SOLICITATION AMENDMENT MODIFICATION DE L'INVITATION

Title - Sujet Furn CAT 1-6 ZIBI Ottawa	
Solicitation No. - N° de l'invitation EP916-211811/A	Amendment No. - N° modif. 001
Client Reference No. - N° de référence du client 20211811	Date 2021-01-11
GETS Reference No. - N° de référence de SEAG PW-\$\$\$PQ-998-79536	
File No. - N° de dossier pq998.EP916-211811	CCC No./N° CCC - FMS No./N° VME
Solicitation Closes - L'invitation prend fin at - à 02:00 PM Eastern Standard Time EST on - le 2021-01-26 Heure Normale du l'Est HNE	
F.O.B. - F.A.B. Plant-Usine: <input type="checkbox"/> Destination: <input checked="" type="checkbox"/> Other-Autre: <input type="checkbox"/>	
Address Enquiries to: - Adresser toutes questions à: Bouvier, Patrick	Buyer Id - Id de l'acheteur pq998
Telephone No. - N° de téléphone (819) 360-2596 ()	FAX No. - N° de FAX () -
Destination - of Goods, Services, and Construction: Destination - des biens, services et construction:

Amendment 001 is raised to publish questions and answers:

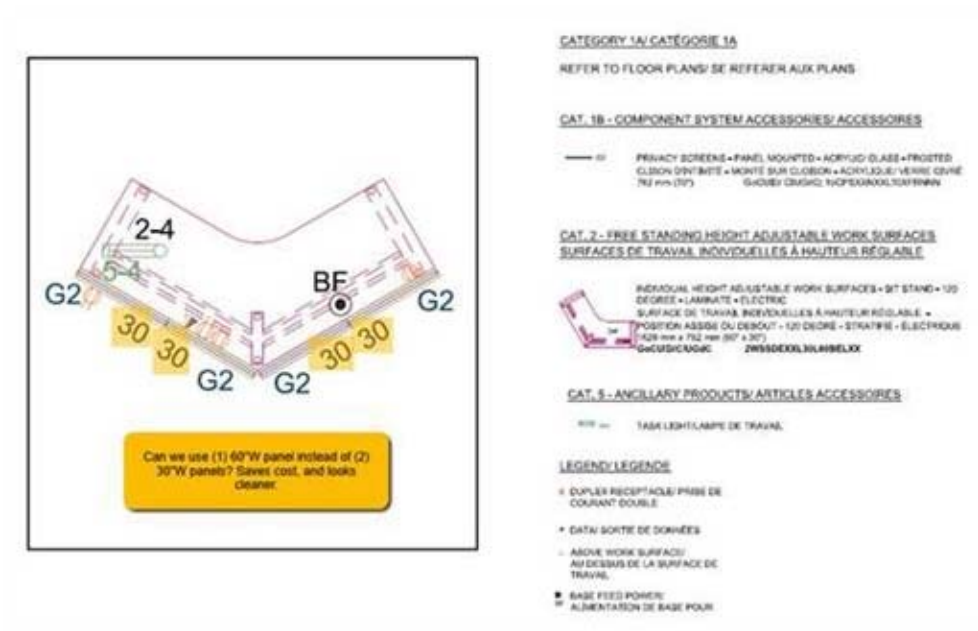
Q6. Can you please confirm if additional wire management is required under the benching or if the trough below is sufficient?

A6. You must supply the wire management as per:

Annex A 1.1 – SPECIFICATIONS FOR WORKSPACES,
Part 3.2 CATEGORY 1B: Freestanding Systems,

article .2 Modular Benching,

sub article .4 Power/Data,

sub article .1 Cable Pathway,

.1 A shared central spine and/or trough must have a cable pathway to accommodate the electrical and voice/data cables.

.3 Cable pathway covers must open and close firmly without the use of proprietary tools. Cables must be capable of extending into the trough without requiring that the cover remain open.

.5 Vertical wire management system must conceal wires running from the floor, wall, or ceiling feed to the cable pathway.

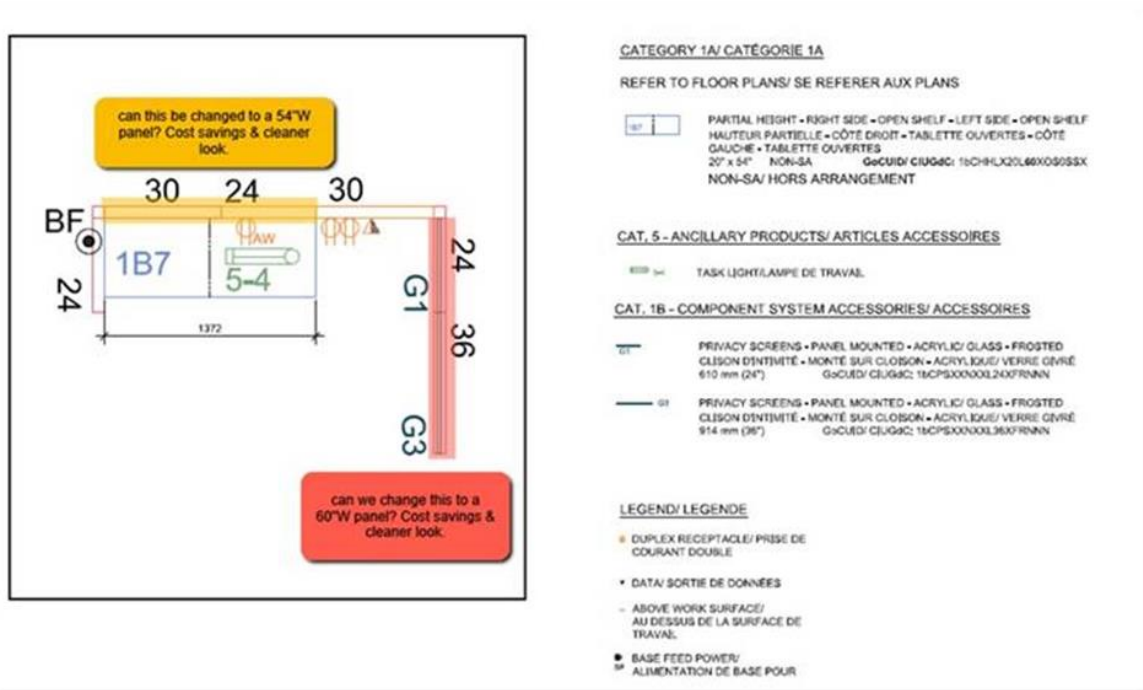
Q8. Would the customer accept the below marked up drawing? (1) 54" wide panel vs. (1) 30" wide + 24" wide (highlighted in yellow), as well as (1) 60" wide panel vs. (1) 24" wide + (1) 36" wide (highlighted in red).

A8. No, please bid as per solicitation
